River Bend Unit 3

Preliminary NRC Acceptance Review Geotechnical Investigation Program October 22, 2008

Reactor Building

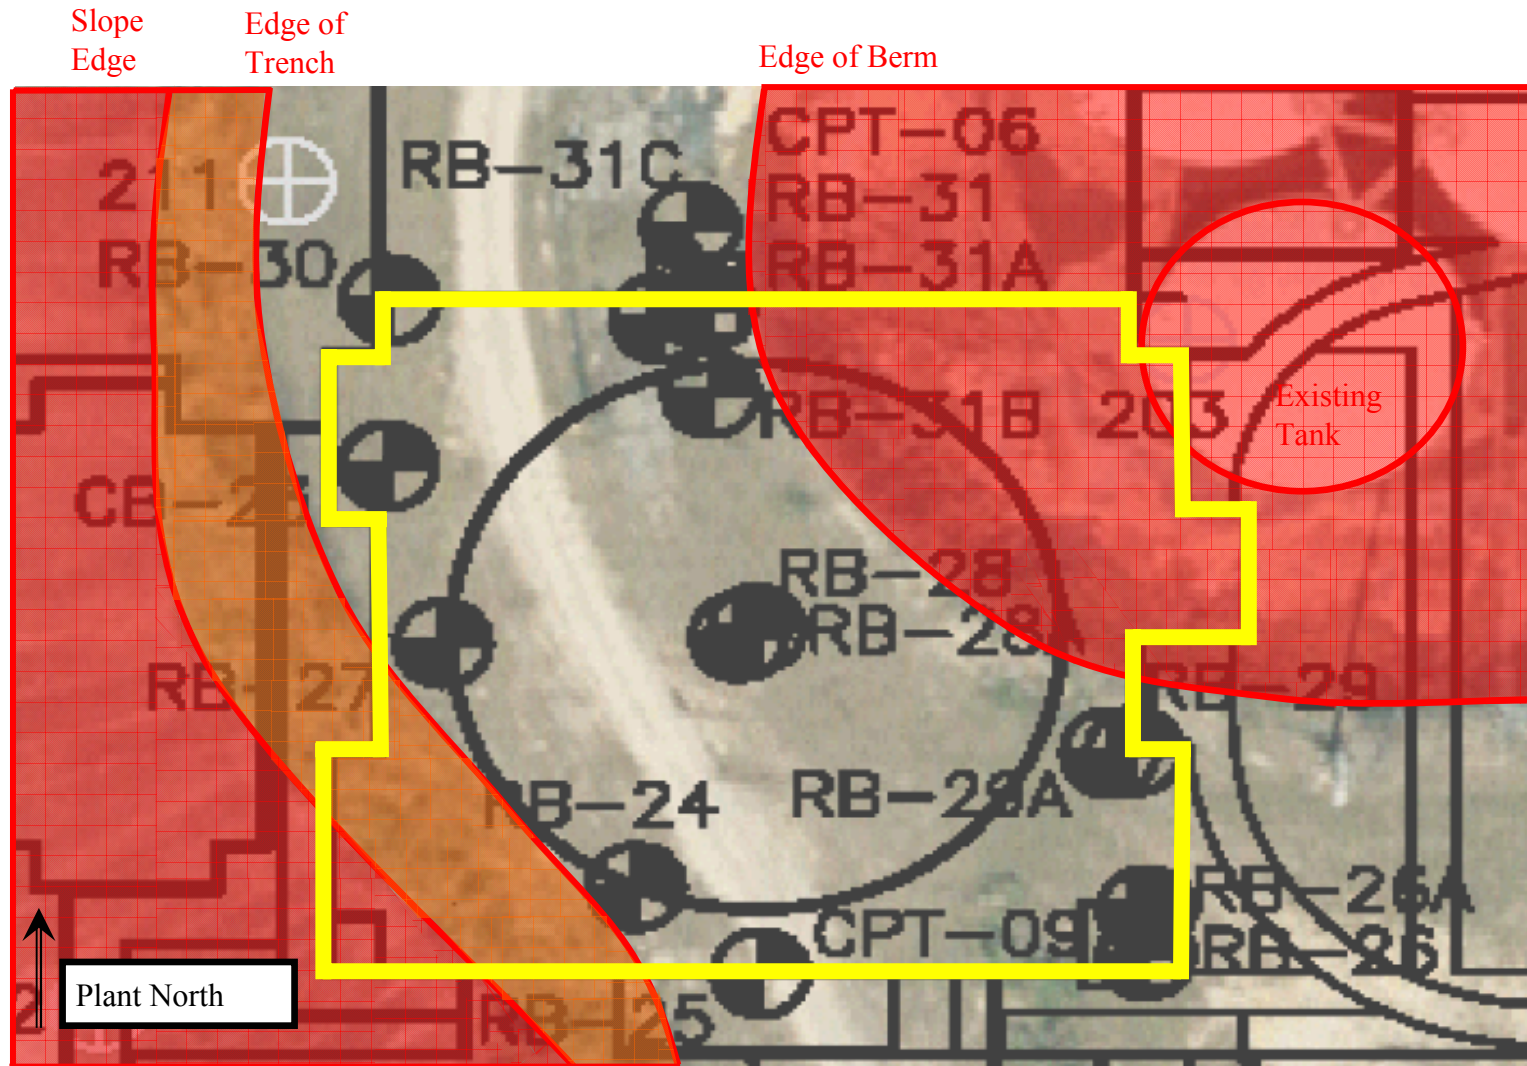
Reactor Building Issue

- No Borings in Northeast Corner or Southwest Corner of Reactor Building Footprint

- 160' x 160' (25,600 SQ FT)
- 8 Borings, 1 CPT

Fuel Building

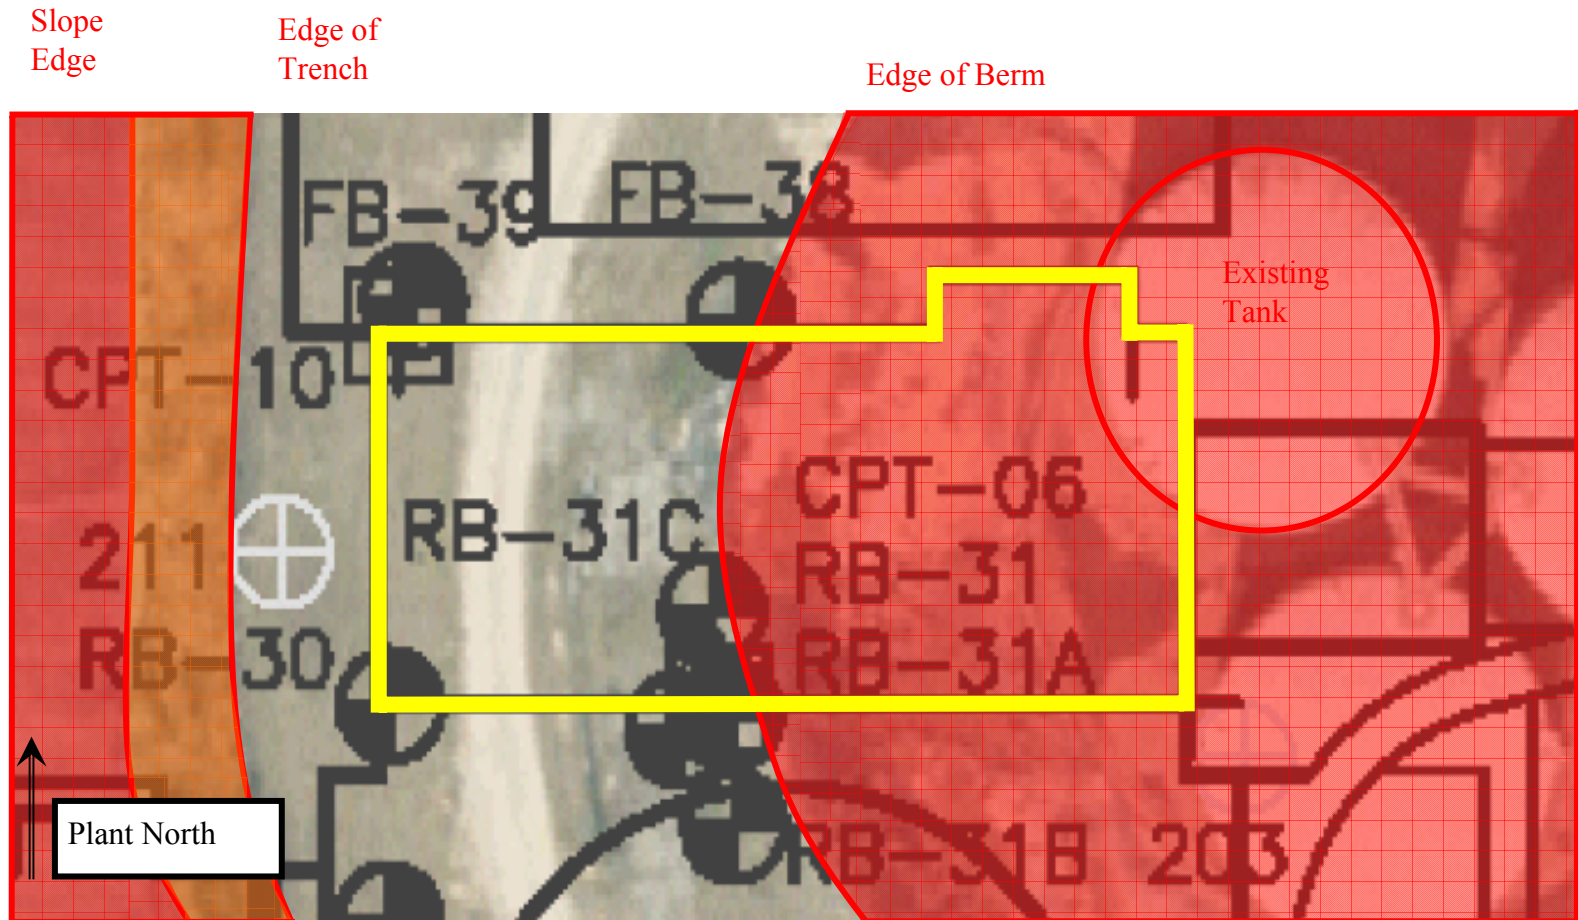
Fuel Building Issue

- No Borings on North-South (East) Side of Fuel Building Footprint

- 70' x 160' (11,200 SQ FT)
- 4 Borings, 2 CPT's

Control Building

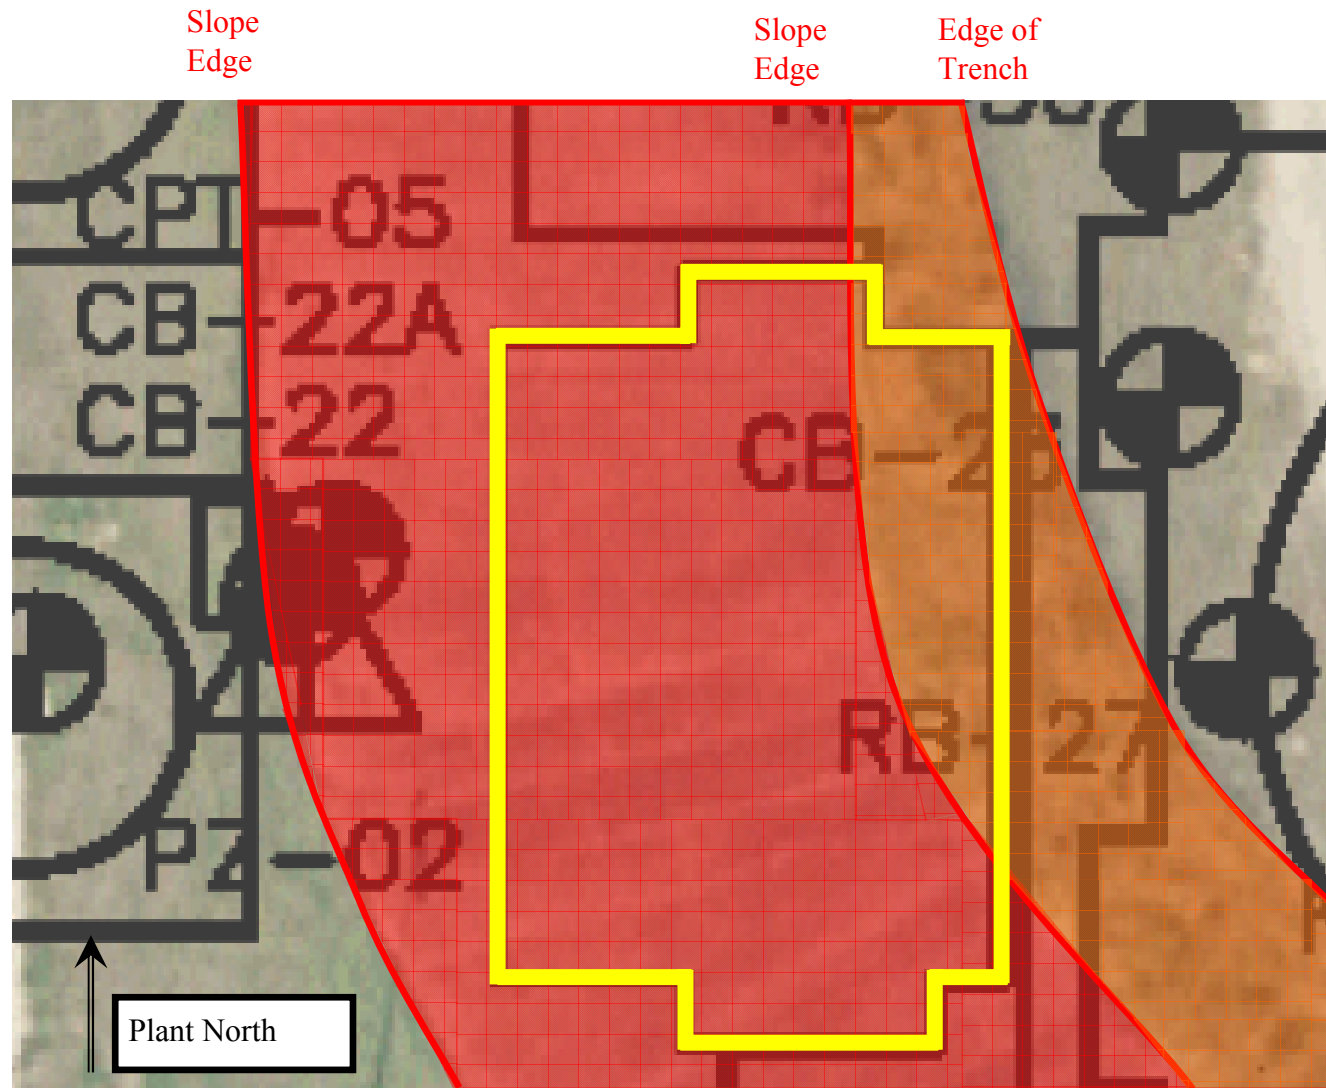
Control Building Issue

- No Borings Beneath Control Building Footprint

- 80' x 100' (8,000 SQ FT)
- 2 Borings, 1 CPT
